**FINAL
EXPLANATION OF SIGNIFICANT DIFFERENCES
FOR THE
T-25 AREA GROUND WATER (OPERABLE UNIT 1)**

**U.S. ARMY NATICK SOLDIER SYSTEMS CENTER
NATICK, MASSACHUSETTS**

**RESPONSE TO USEPA COMMENTS
ON
DRAFT EXPLANATION OF SIGNIFICANT DIFFERENCES
FOR THE
T-25 AREA GROUND WATER (OPERABLE UNIT 1)**

Figure 2-1
Locations of T-25; Buildings 22 and 36; and Buildings 63, 2, and 45 Areas

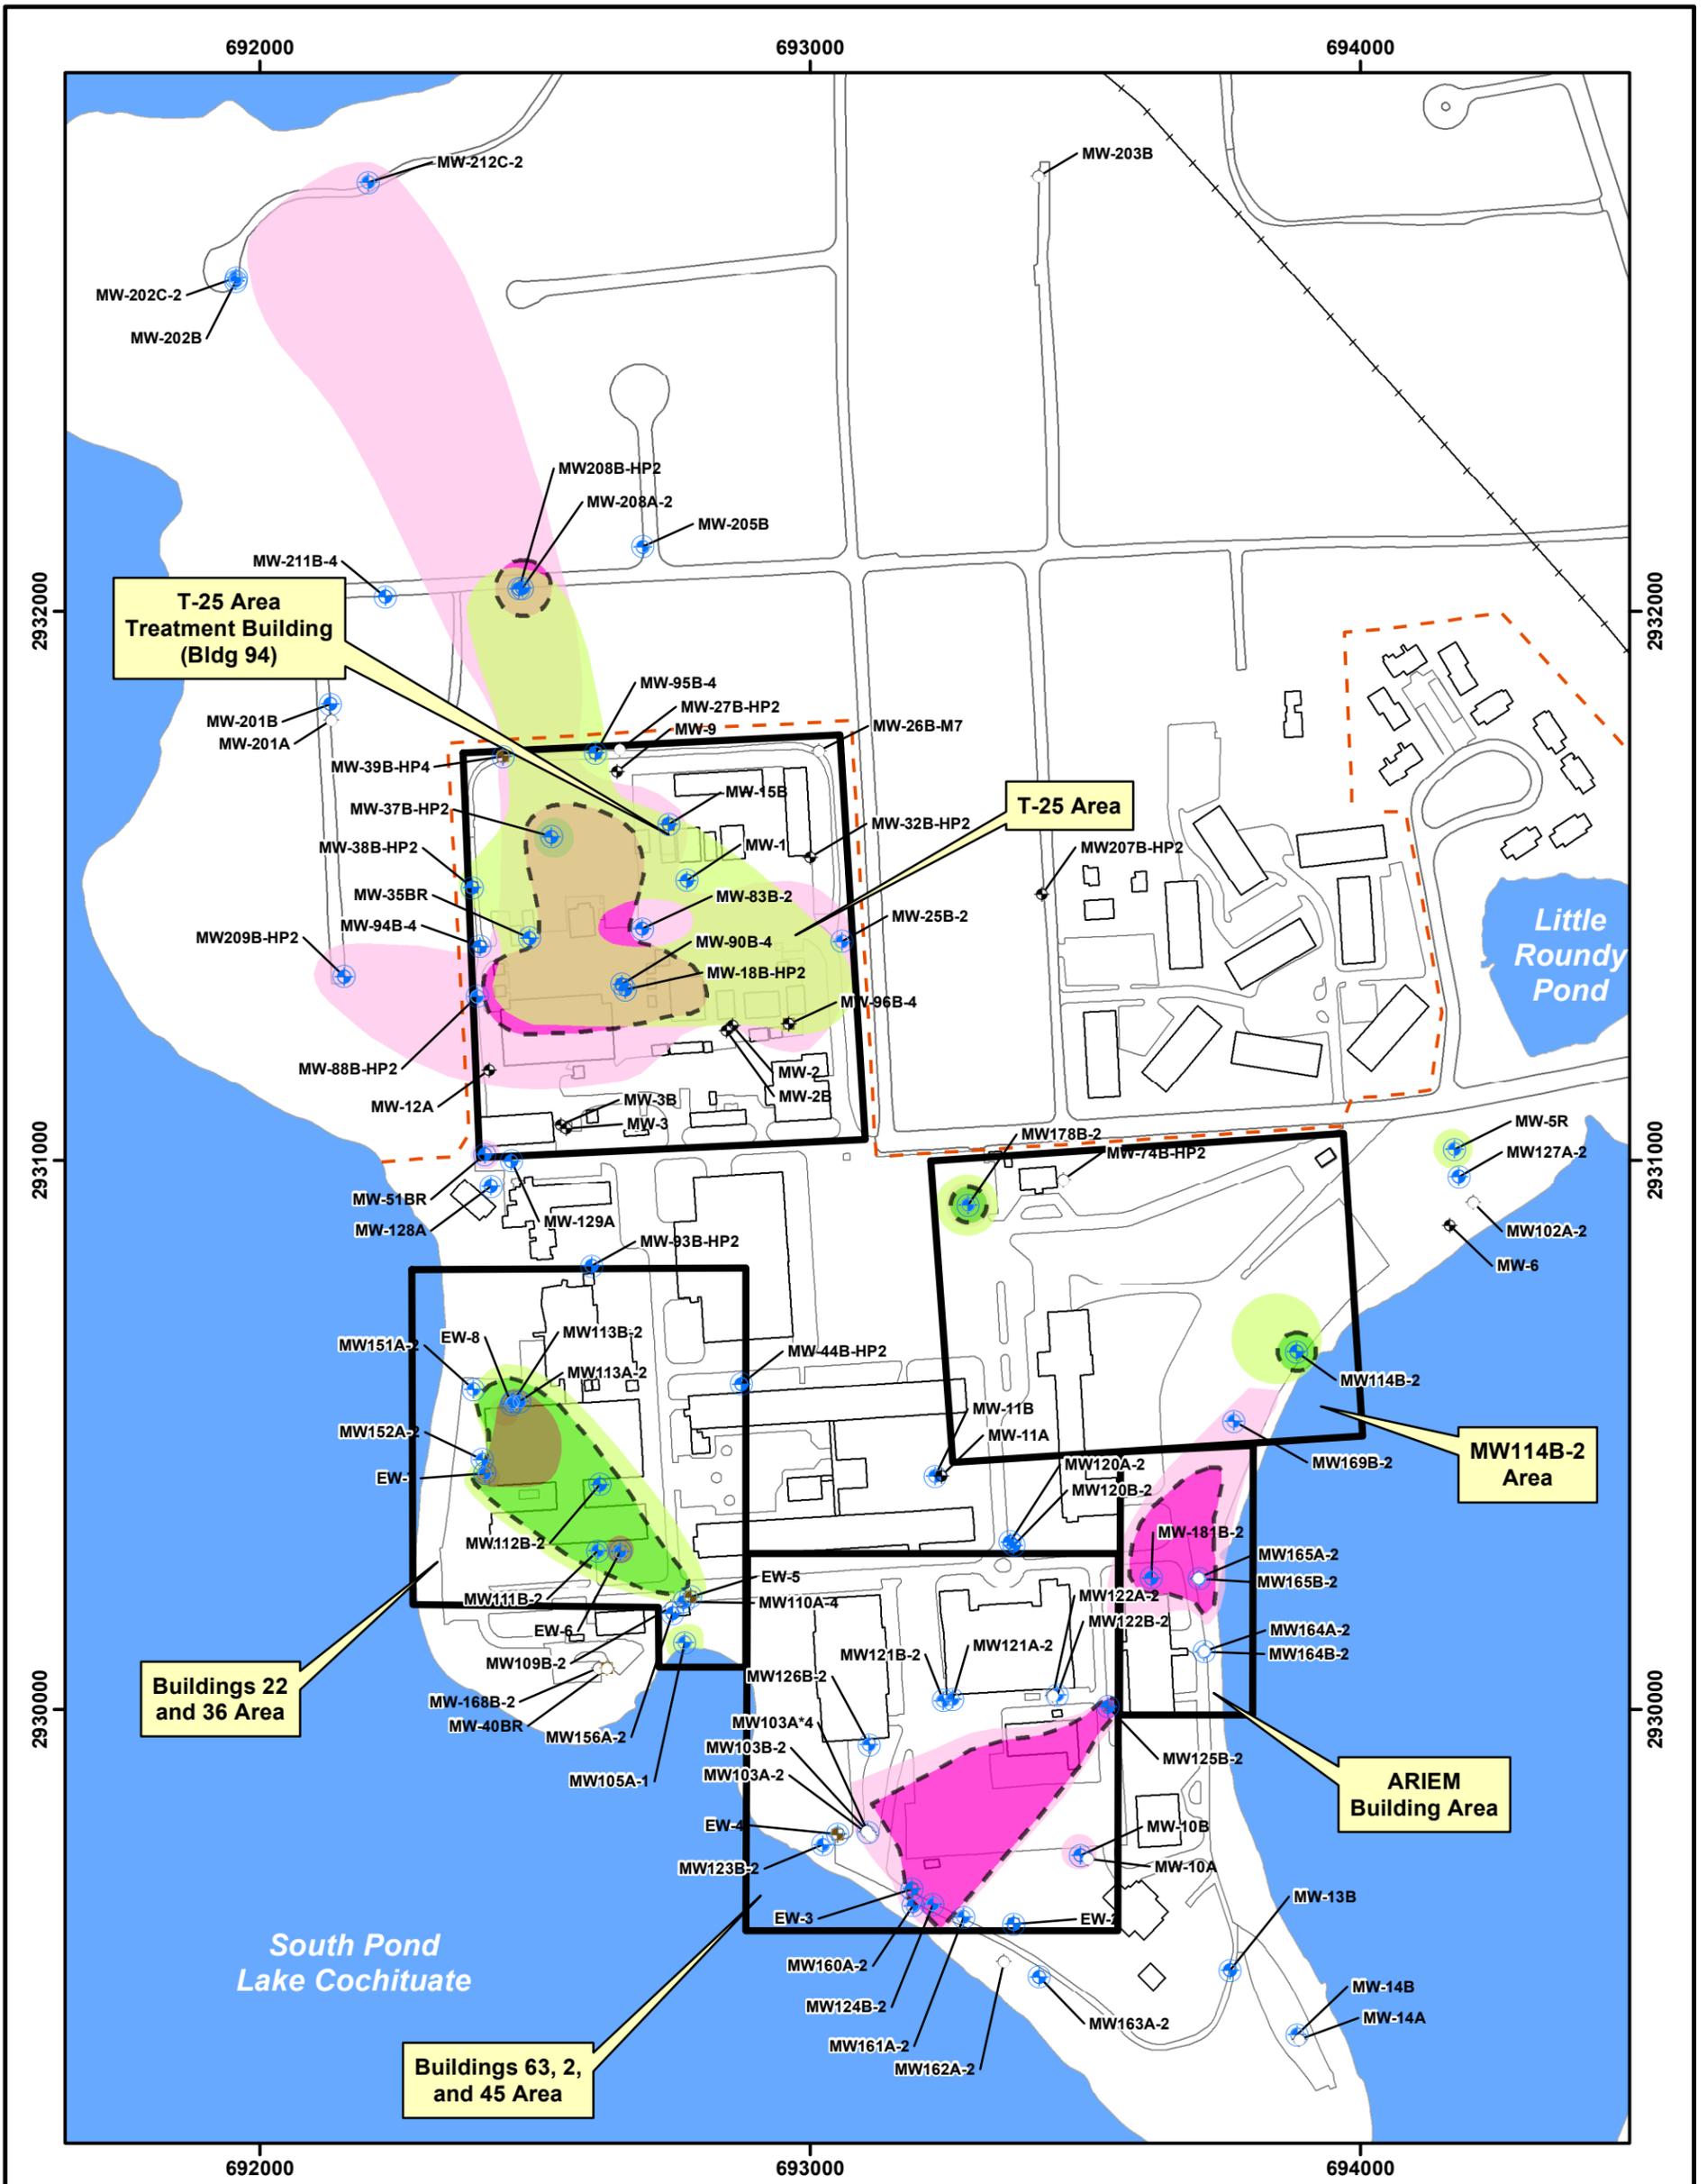
Comment No. 12: Figure 2-1. should include the location of MW181B-2 on the figure as this is an ARIEM well to be slug pumped.

Response: Figure 2-1 has been revised to include MW181B-2.
